MEMORANDUM

SUBJECT: Dreamfinders Model Approvals

DATE: December 19, 2022

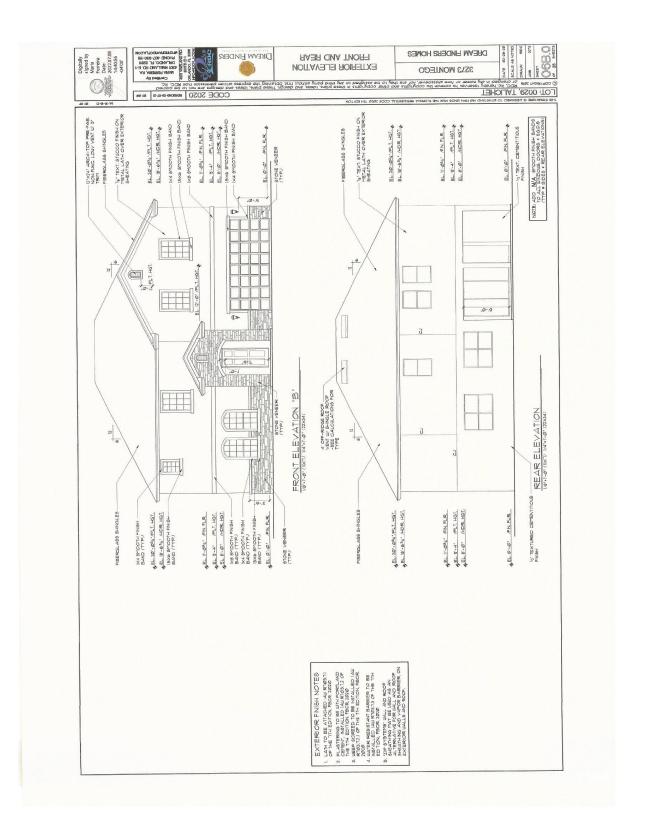
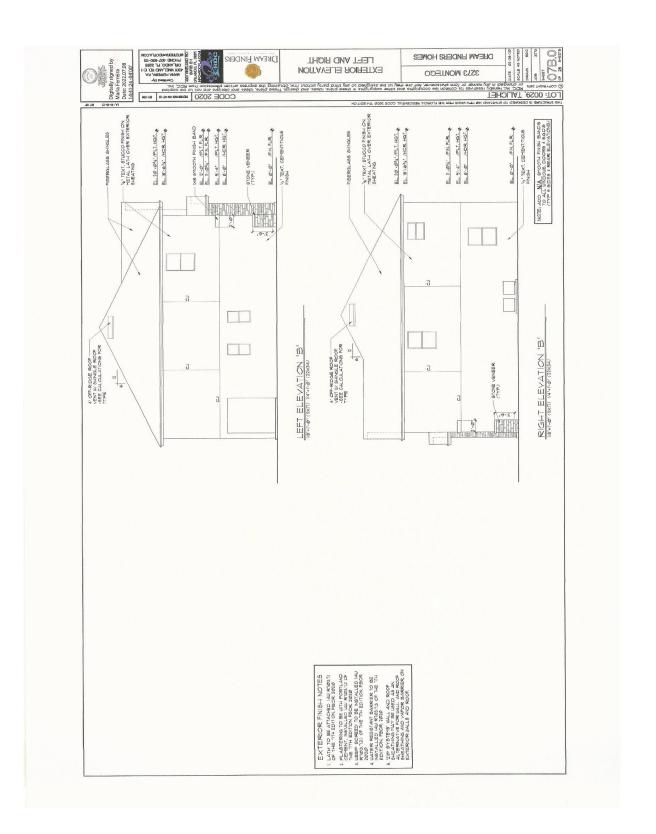
Montego B: The unit is two-stories with a fiberglass shingle roof, stucco and stone front exterior and varied roof lines as required. The design detail meets the requirements for the primary and secondary facades, and it meets the two-car garage requirement.

Montego C

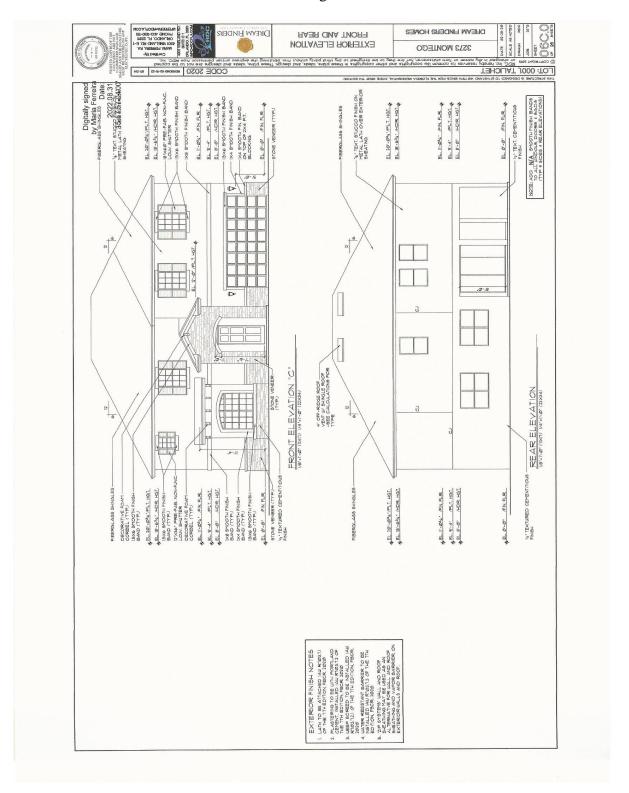
Montego C: This unit is a very similar floor plan as the Model B. It uses the same exterior materials and a very similar level of detailling. This unit also meets the two-car garage requirement.
